Amendments to the Drawings:

Remarks/Arguments

FIG. 4

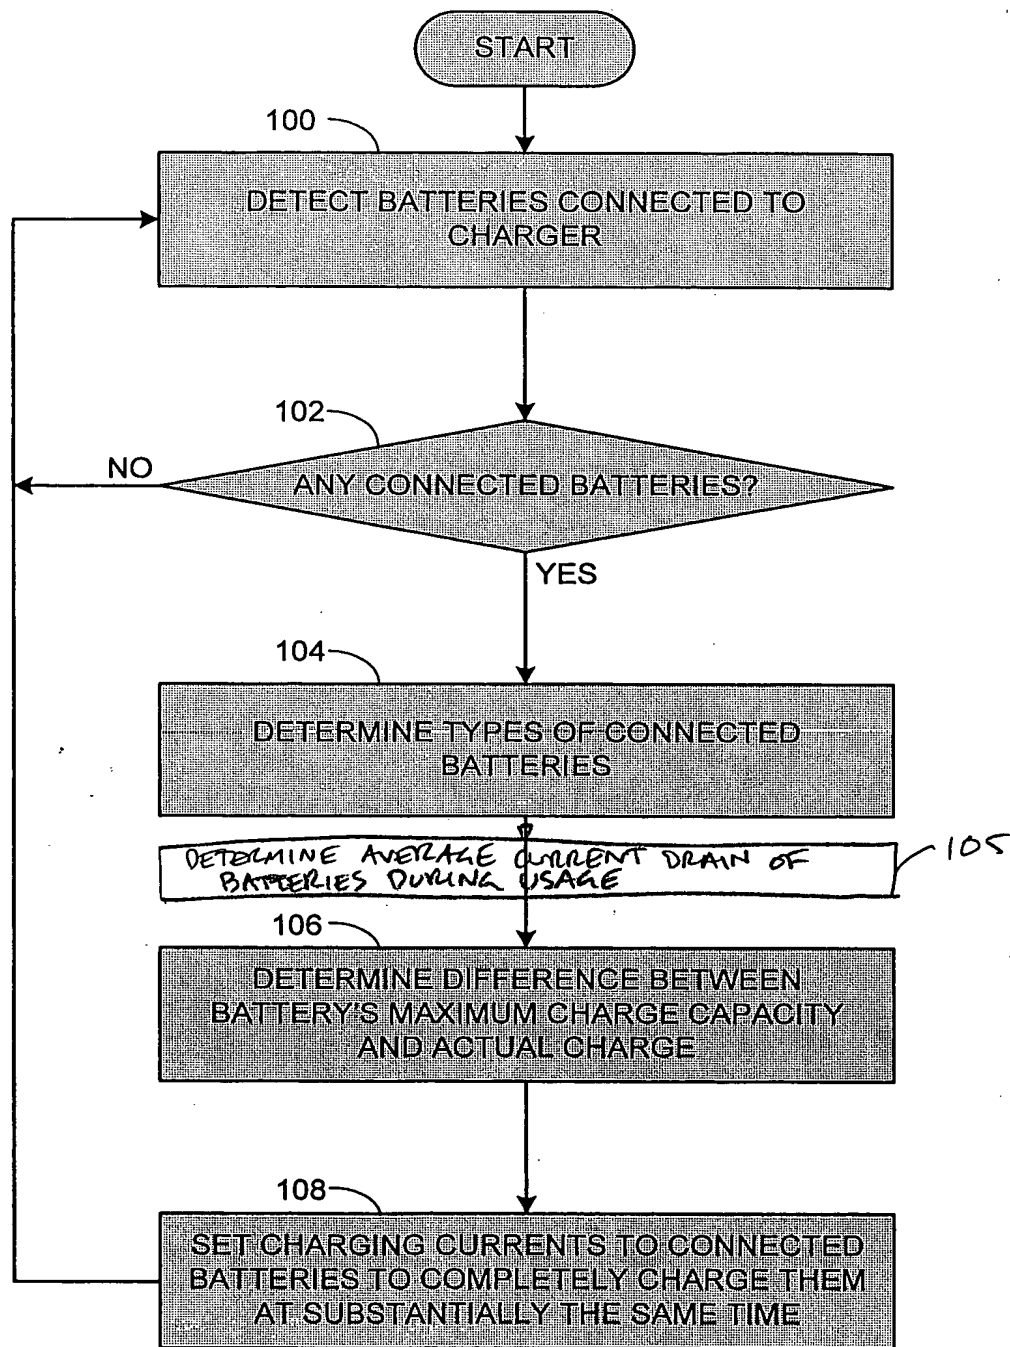
The attached sheet of drawings includes changes to Fig. 4. This sheet, which includes insertion of a new step designated by reference numeral 105, replaces the original sheet Fig. 4.

Figure 4 and the corresponding section of the description are amended to include a new step designated by reference numeral 105. Step 105 shows determining the average current drain of the batteries during usage, as requested by the Examiner.
